SSD-10420

SECTION S4.55(1A) MODIFICATION REPORT 6A WATSFORD ROAD, CAMPBELLTOWN

Prepared by Planning Lab
Issued 10 August 2022

Figure 3 - Extract from original survey by Project Surveyors identifying the Benchmark at 60.06 and reference mark at 60.37

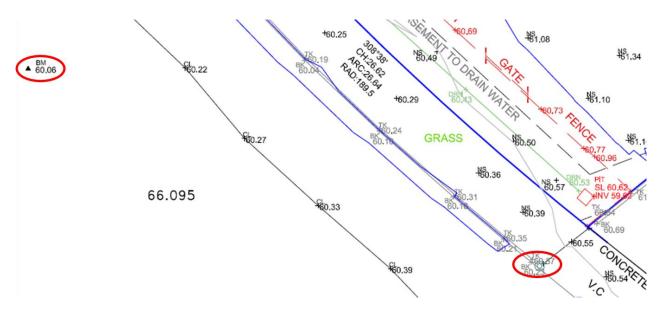
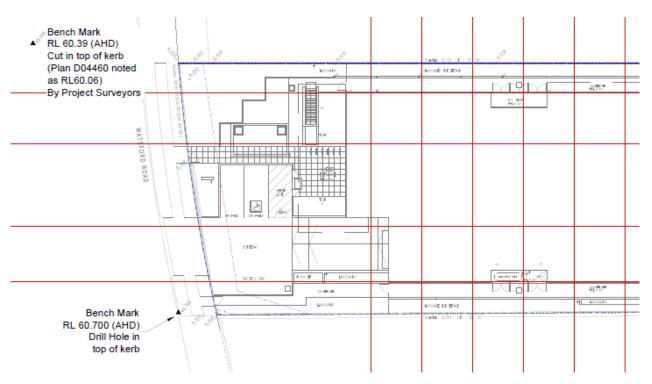
The design originally approved under SSD-10420 had been developed using a site survey by "Project Surveyors" (plan D04460-Detail) that was lodged as part of SSD-10420. Since receiving approval, it has been discovered that the datum origin noted on plan D0446-Detail was from PM 55148 which is situated approximately 55km away in Waverley. It's not currently clear why or how this survey mark was used to obtain the AHD for the project.

Geosurv has produced a new site survey to correct the inaccuracies and accompany this application. This survey shows that the actual AHD of the site is 330mm higher than shown on D0446-Detail. As a result of this error, the architectural plans depicted RLs that were 330mm lower than they should have been.

This modification corrects the RLs of the project but also increases the depth of the basement by 660mm and reduces the Ground Floor Level by 60mm. As a result, the basement floor to floor level is increased from 3m to 3.6m and the building envelope from the Ground Floor is shifted downwards into the site by 60mm as demonstrated in Table 1.
